PD Modification Application: PRS 26-0750
Zoning Hearing Master Date: NA
BOCC Land Use Meeting Date: June 9, 2026

The applicant is requesting a minor modification to PD 85-0206 (as most recently modified by MM 25-0265) to allow for a 6,000-square-foot increase to the permitted gross floor area, modify the trip cap, and relocate the sidewalk along Highview Road from the public right-of-way to the subject parcel.

2.4 Proposed Site Plan (partial provided below for size and orientation purposes. See Section 8.2 for full site plan)

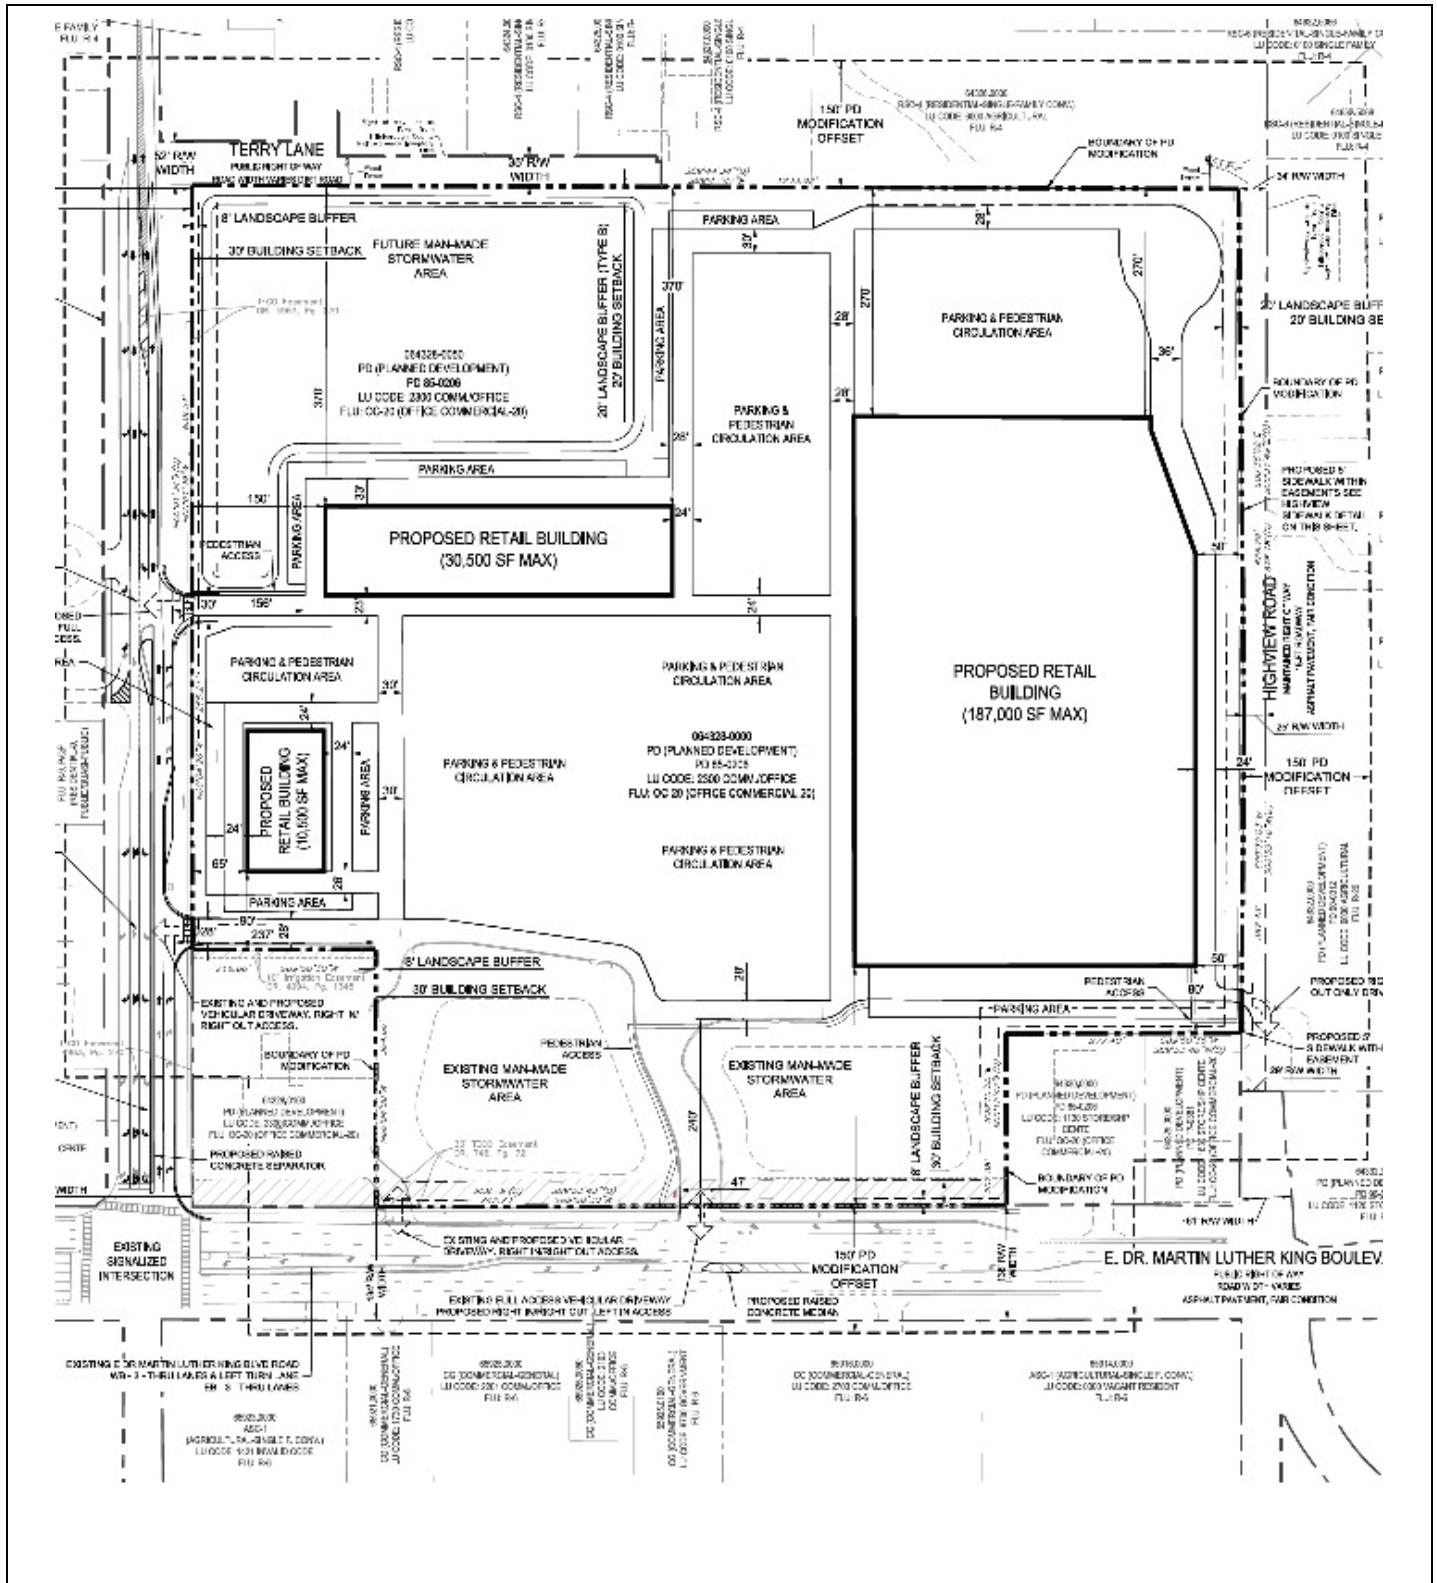
Staff finds that relocating the sidewalk from the Highview Road right-of-way to the subject property allows the required tree plantings to be placed within 10 feet of the property line as required by the LDC. Furthermore, the proposed general site plan orients commercial development away from nearby residential areas. The proposed Floor Area Ratio of 0.17 is below the 0.75 permitted under the OC-20 Future Land Use designation. Accordingly, staff finds that relocating the sidewalk and increasing the gross floor area from 222,000 square feet to 228,000 square feet will have minimal impact on neighboring properties and remains compatible with local zoning and development patterns.

Prior to certification, the applicant shall revise the general site plan to change all references of MM 25-0265 to PRS 26-0750 and identify proposed site plan as Sheet 3 of 3 instead of Sheet 1

Figure 1. Location Map

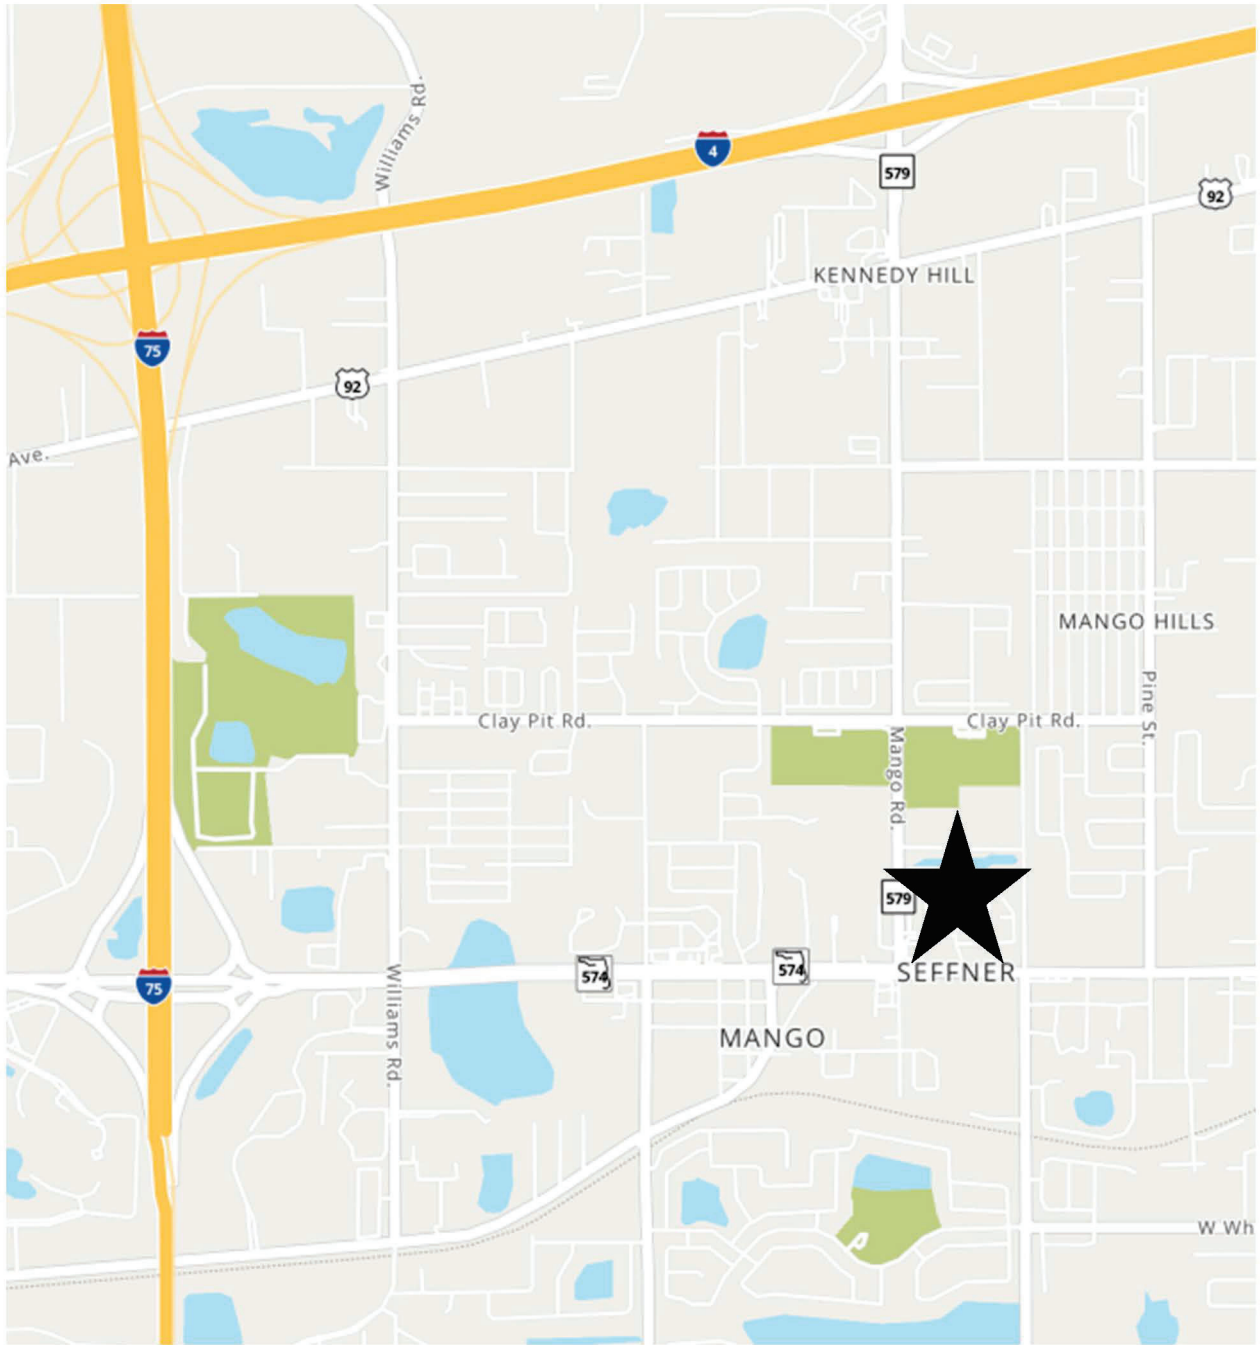
The request is to maintain the existing access locations that have served this project for over 30 years. With the introduction of a raised median, the southern access on Mango Road will meet the connection spacing standard of 245 feet. However, while the northern access meets the connection spacing standard of 245 feet for driveways on the east side of Mango Road, there are two driveways (noted as C and D in Figure 2) on the west side of Mango Road that serve the existing school that do not meet the connection spacing standard. The existing driveway

The existing full access to the project, is approximately 15 feet south of the existing driveway to Mango Elementary front entry (noted as Driveway C in Figure 2). This access point has relatively low traffic volumes and is not the primary parent pick-up and drop-off location, which is the driveway to the south (noted as Driveway D in Figure 2). To minimize the conflict to the two Mango Elementary School driveways west of the primary full access to the project, the application will extend the southbound right turn lane on the west side of Mango Road, to allow for the existing right turn lane to serve both the main entrance driveway and also the parent pick-up/drop-off right-in only driveway. Given the Mango Elementary School layout, the historic operation of the project driveway and the proposed improvement to the Mango Elementary driveway, the driveway spacing would not be detrimental to the public health, safety and welfare of the motoring public.

The County Engineer has reviewed zoning modification application # 26-0750 and determined the changes to be de minimis. As such, the previous approval shall stand.

Figure 2: Proposed Typical Sections

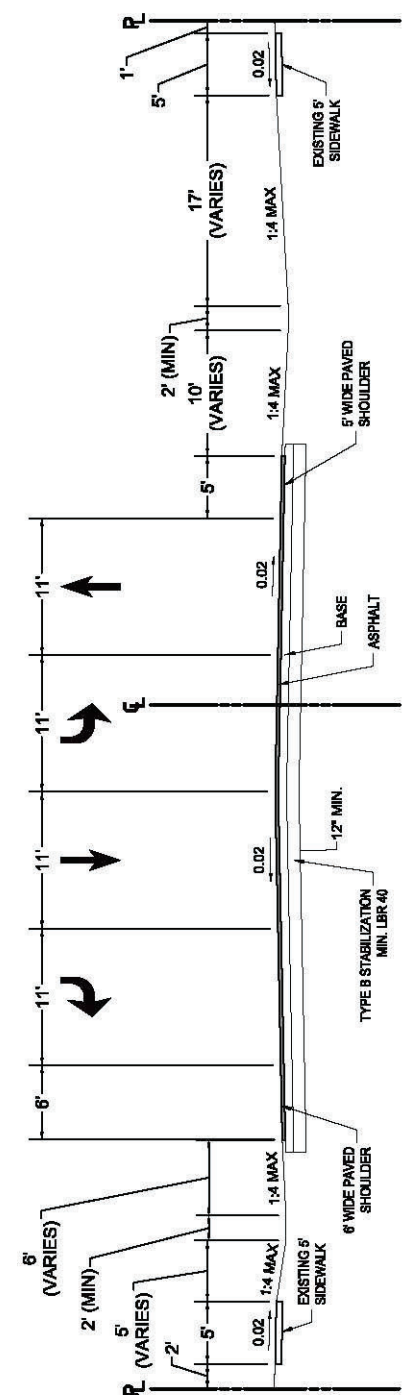
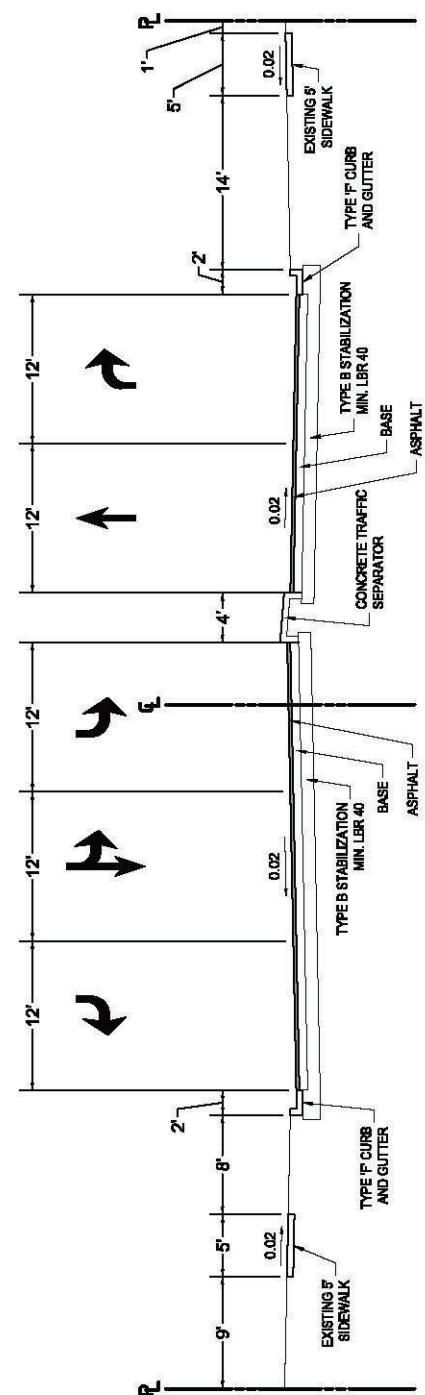
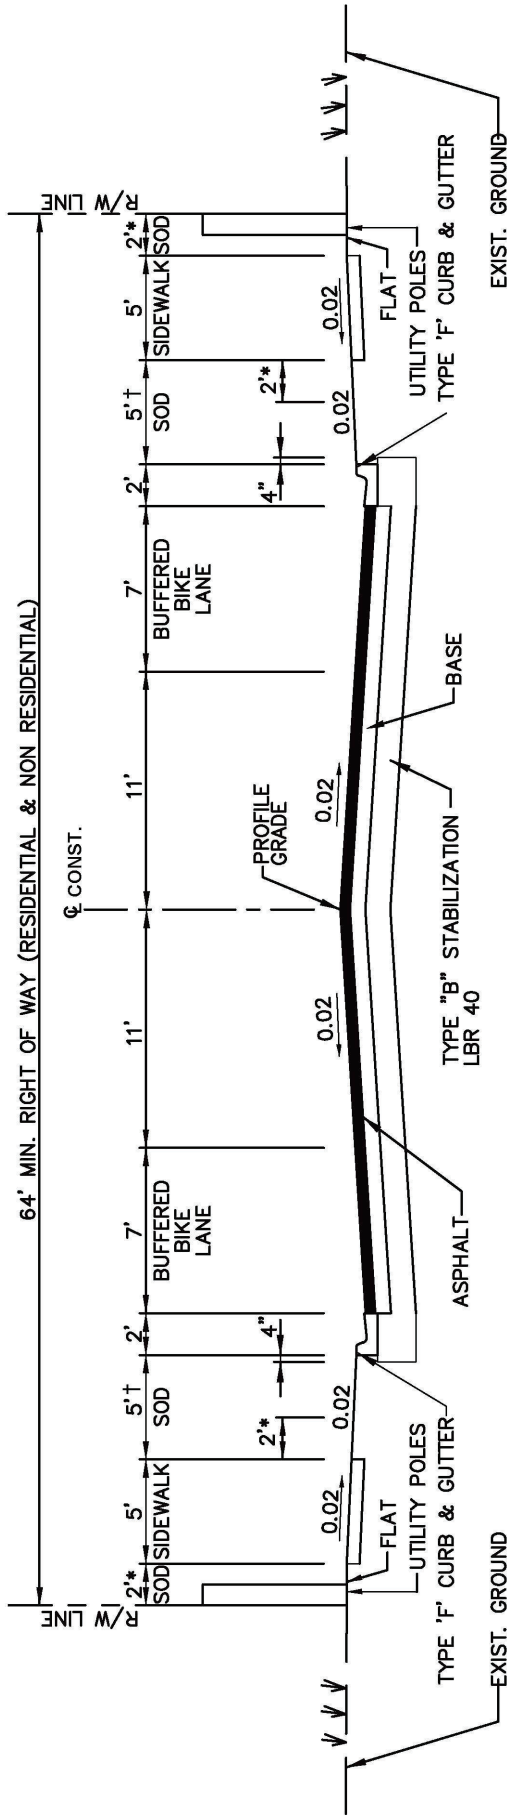
1. The request is to provide 11-foot travel and turn lanes instead of the 12-foot lanes. According to the Florida Green Book, on a suburban roadway where the speed limit is between 40 and 45 mph, 11-foot lanes may be used. The post speed limit on Mango Road is 45 mph.
2. Provide an 11-foot wide, 285-foot-long southbound left turn lane at the project northern driveway. The length includes a 50-foot taper.
3. Provide an 11-foot wide, 250-foot-long northbound right turn lane at the project northern driveway. The length includes a 50-foot taper.
4. The open drainage will be reduced in width from the 19 feet identified in the TS-7 but will maintain the maximum 1:4 side slope.
5. The 5-foot paved shoulder is being provided on the east side of Mango Road. However, the existing paved shoulder on the west side of Mango Road is approximately 3 feet, which will remain unchanged.

The proposed typical section is shown in Figure 2 and the proposed improvements are shown in Figure 3.

The County Engineer reviewed the changes proposed by this PRS application and determined that a modification to this Design Exception was not needed. If PRS 26-0750 is approved by the Board of County Commissioners, the County Engineer will approve the above referenced de minimis Design Exception request.
